**FINAL MONITORING WELL INSTALLATION, DESTRUCTION,  
REHABILITATION, AND REPAIR WORK PLAN**

**Hunters Point Naval Shipyard  
San Francisco, California**

*Response to Comments on the Draft Monitoring Well Installation, Destruction, Rehabilitation, and Repair Work Plan, Hunters Point Naval Shipyard, San Francisco, California. October 2018*

**FIGURE 2**

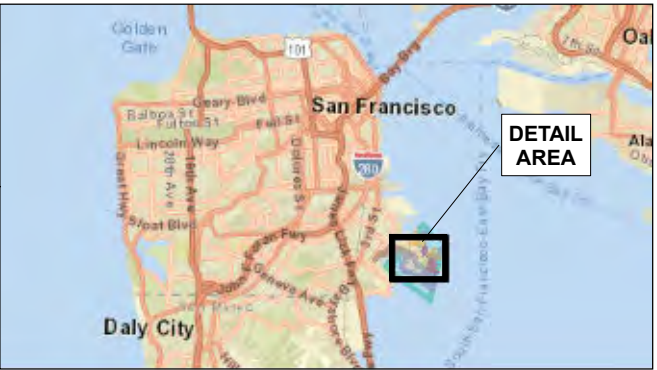
6	Figure 2, Parcel Location Map	Parcels UC-1 through UC-3 are not labeled on Figure 2. While the color coding defined in the legend denotes the location of these parcels, all other parcels include labels. Therefore, Parcels UC-1 through UC-3 should also be labeled for consistency. Please revise Figure 2 to include labels for Parcels UC-1 through UC-3.	Figure 2 has been updated to include the labels for Parcels UC-1, UC-2, and UC-3.	No Additional Comments

**FIGURE 3**

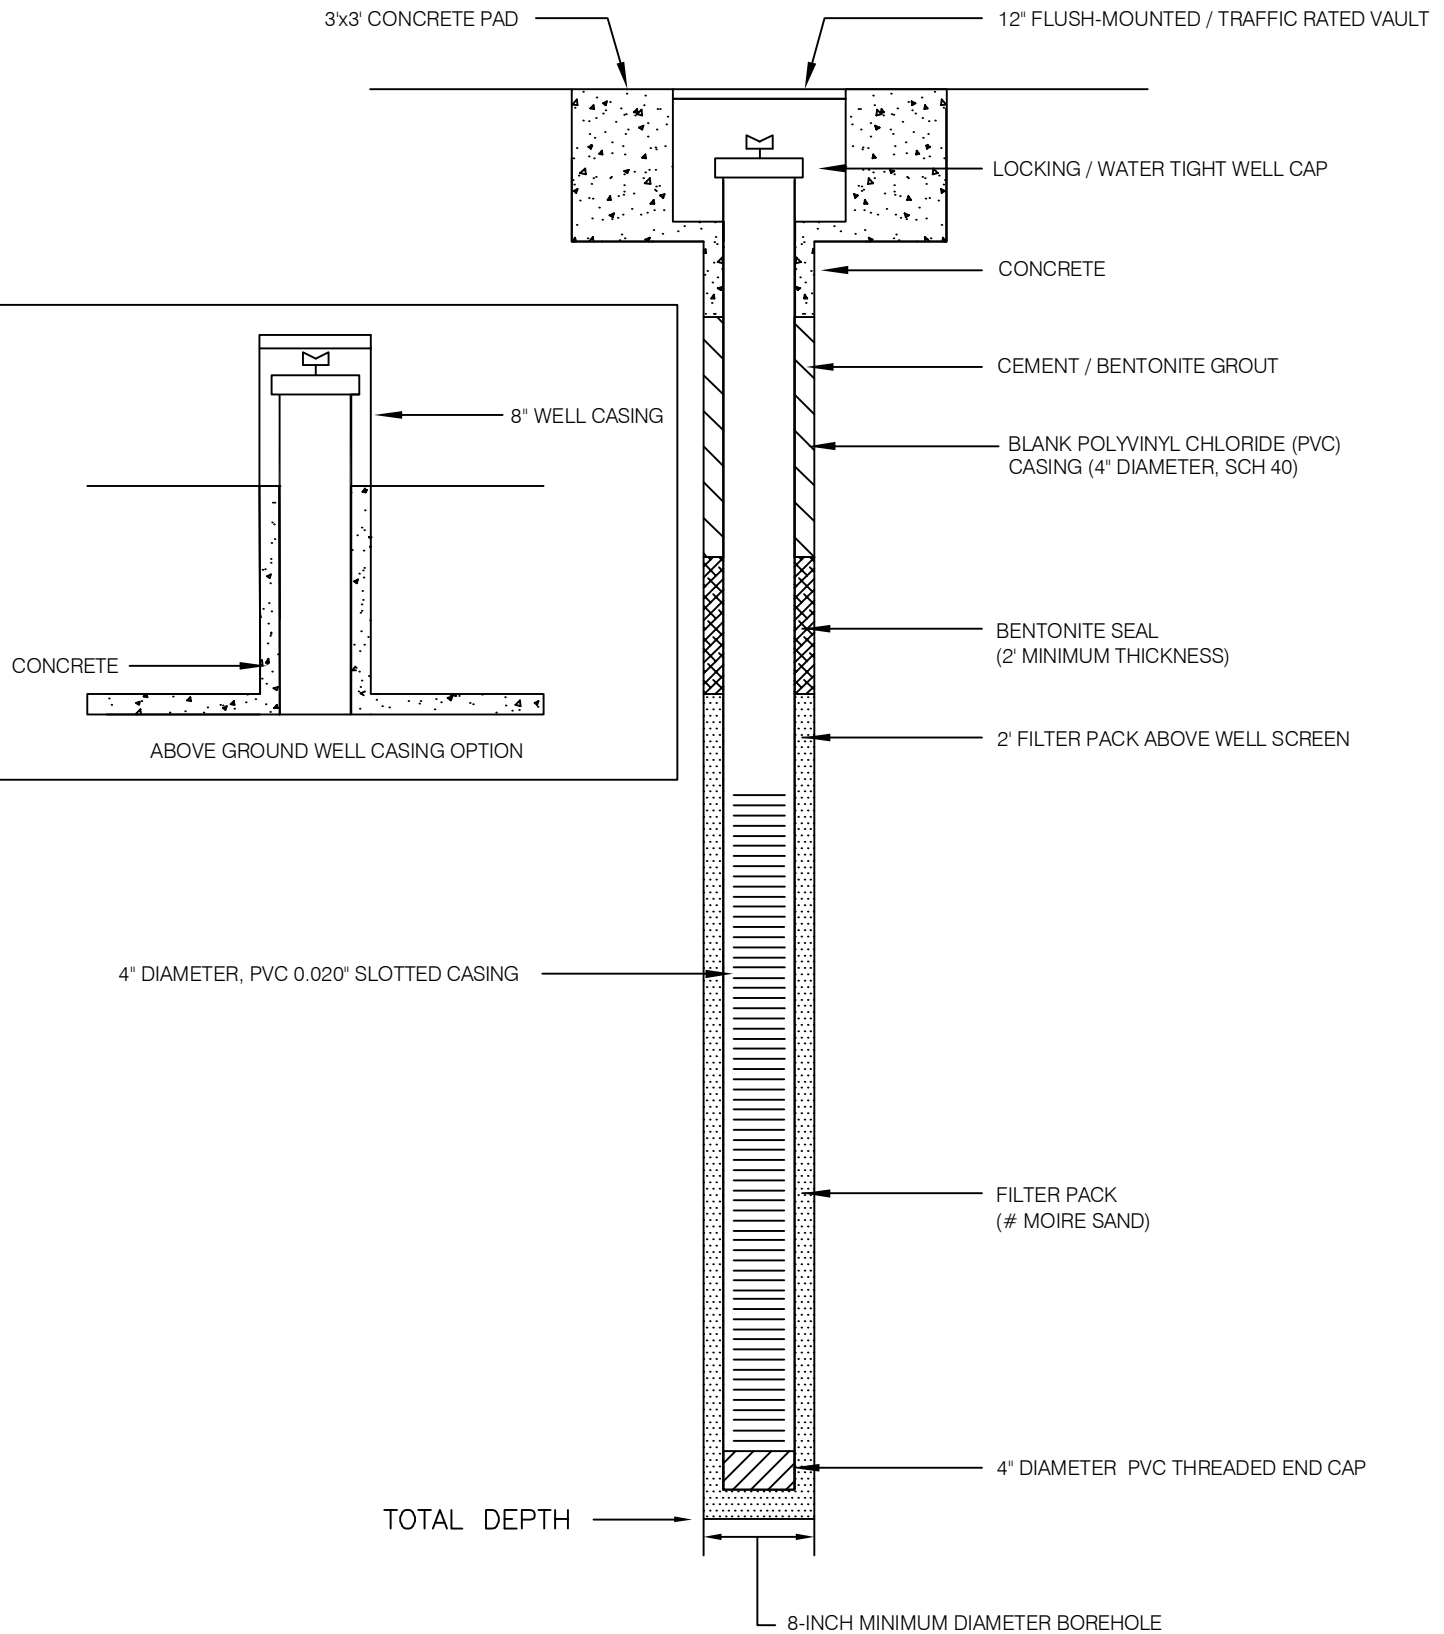
<b>No.</b>	<b>Section/Page</b>	<b>Comment (11/13/18)</b>	<b>Response (11/27/18)</b>	<b>Comment (12/20/18)</b>	<b>Response</b>
1	Section 3.3, Monitoring Well Destruction, Page 3-2 and Figure 3, Monitoring Well to be Installed, Decommissione d, Rehabilitated, or Replaced:	According to the text of Section 3.3, wells IR01MW-7 and IR01MW53B will be decommissioned and replaced, but the legend of Figure 3 indicates that these wells will be decommissioned or replaced. Please revise the Well Work Plan to resolve this discrepancy.	Monitoring wells IR01MW-7 and IR01MW53B will be decommissioned and then replaced. Figure 3 has been updated to be consistent with the text in Section 3.3.	No Additional Comments	
2	Section 3.4.1, New Monitoring Well Installation, Page 3-3 and Table 2, Monitoring Well Construction Details:	The third paragraph of Section 3.4.1 indicates that “up to 20-feet of screen” will be installed for the two new monitoring wells; however, Table 2 indicates that the majority of the wells have screens of 10 to 15 feet and only a few have lengths of 20 feet. The text should be revised to propose 10-foot well screens for the new monitoring wells or to explain why screen lengths of 20 feet are proposed. Please revise Section 3.4.1 to propose 10-foot well screens for the new monitoring wells or to explain why screen lengths of 20 feet are proposed for the two new monitoring wells.	Replacement and newly installed monitoring wells will have screen lengths that are no longer that 10 feet in accordance with the DTSC and EPA guidance.  Section 3.4.1 New Monitoring Well Installation has been updated to state:  “and up to <i>10-feet</i> of screen...”	No Additional Comments

3	Section 3.5, Monitoring Well Rehabilitation and Repairs, Page 3-4 and Figure 3, Monitoring Well to be Installed, Decommissione d, Rehabilitated, or Replaced	The second paragraph of Section 3.5 states that “Trevet will also replace well boxes or mounts at 13 existing monitoring wells,” but only 12 wells are identified for box replacement on Figure 3 (denoted by grey symbols). Based on the list of wells in Section 3.5, well IR01MW366B appears to be missing from Figure 3. Please revise the Well Work Plan to resolve this discrepancy.	Figure 3 has been revised to be consistent with the Work Plan.	No Additional Comments

No.	Section/Page	Comment	Response
2	Section 3.4.2, Replacement Monitoring Well Installation, page 3-4, second paragraph, and Figure 3 Monitoring Wells to be Installed, Decommissioned, Rehabilitated, or Replaced	The second paragraph states “the replacement wells will be located approximately 10 feet from the original monitoring well.” Please update this statement to reflect the designated locations for these wells that were already accepted by the BCT. The proposed locations for wells IR06MW54FR and IR06MW55FR were separately identified on Robinson Street in attached Drawing C4.0, Artists Parcel Mass Grading Demo and Utility Plans Composite Utility Map, that was sent to the Navy on 9/27/18 and accepted by the BCT in August 2018. Please update the well locations for IR06MW54FR and IR06MW55FR on Figure 3 to be consistent with the locations depicted on Drawing C4.0.	<p>Section 3.4.2 has been updated to state:</p> <p>“The previous well locations are shown in Figure 3. The replacement monitoring wells will be located approximately 10 feet from the original monitoring well <i>with the exception of monitoring well IR06MW54FR and IR06MW55FR which will be located as identified in the Final Restricted Activities Work Plan, Hunters Point Artists Parcel Project, Navy Parcels B-1, C, and UC-2 report due to construction activities in the area (Geosyntec 2016).</i>”</p> <p>The well locations shown in Figure 3 are previous well locations; the well locations for IR06MW54F and IR06MW55F were left in their original locations on Figure 3.</p>

Figure 5  
Project Schedule  
Well Installation, Destruction, Rehabilitation and Repair Work Plan  
Hunters Point Naval Shipyard, San Francisco, California

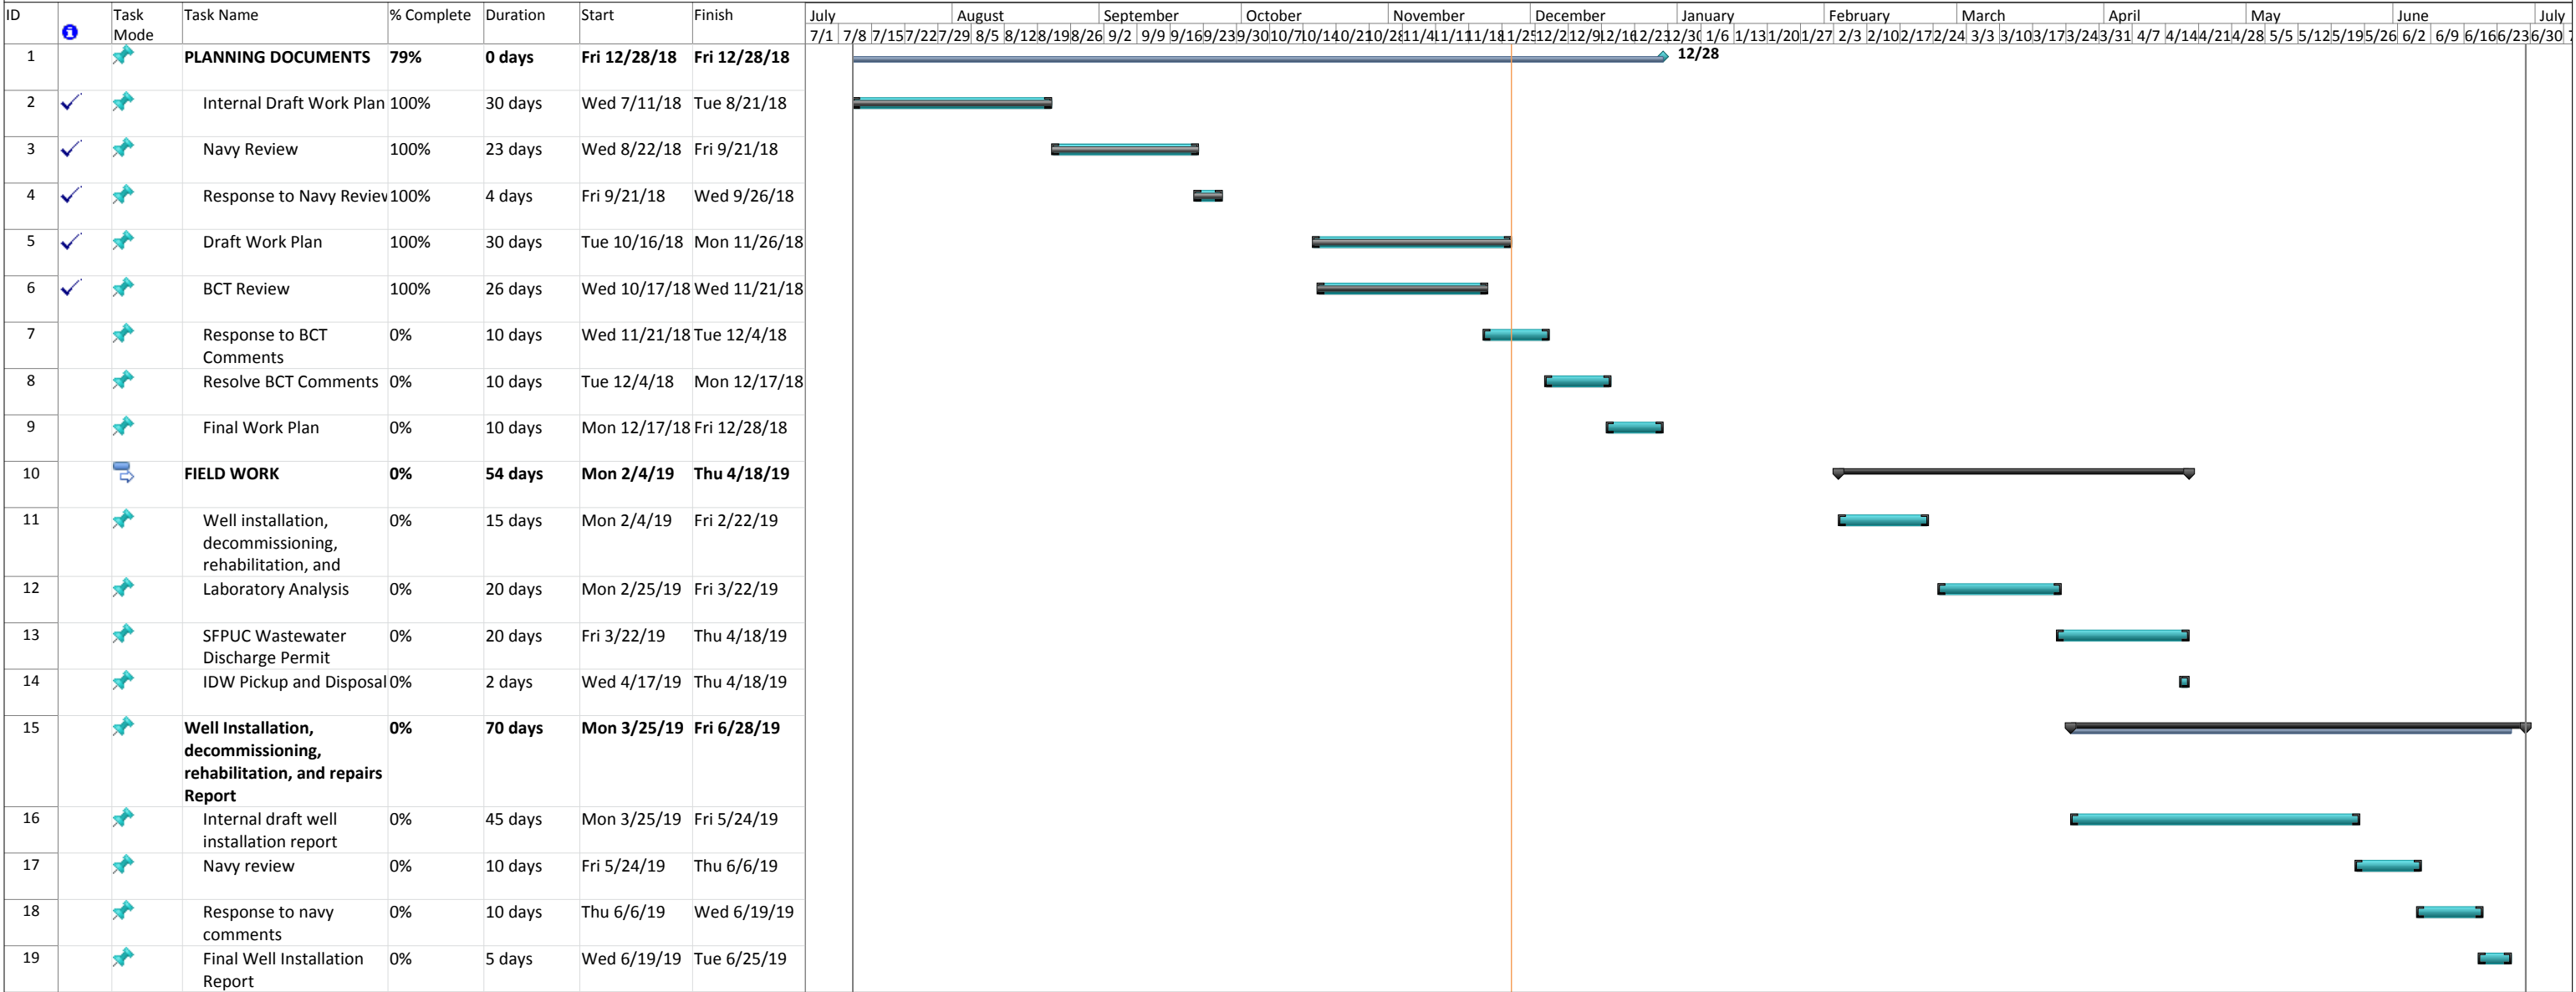
2	Not Applicable	The Well Work Plan does not include a schedule. Please revise the Well Work Plan to include a schedule outlining periods for the activities planned, such as mobilization, well repairs, well installations, reporting, etc.	The work plan has been revised to include Figure 5 which is project schedule for the work proposed in this work plan. A project management plan section (Section 6) was also incorporated into this work plan to discuss the management structure of the tasks described in this work plan.	The response addressed the comment; however, the text in new Section 6.3 references Figure 6 for the project schedule, but the response and revised list of figures in the Redlin Well Work Plan indicate the project schedule is presented on Figure 5. Please revise Section 6.3 to reference Figure 5 rather than Figure 6.	Section 6.3 has been updated to reference Figure 5 as the project schedule.
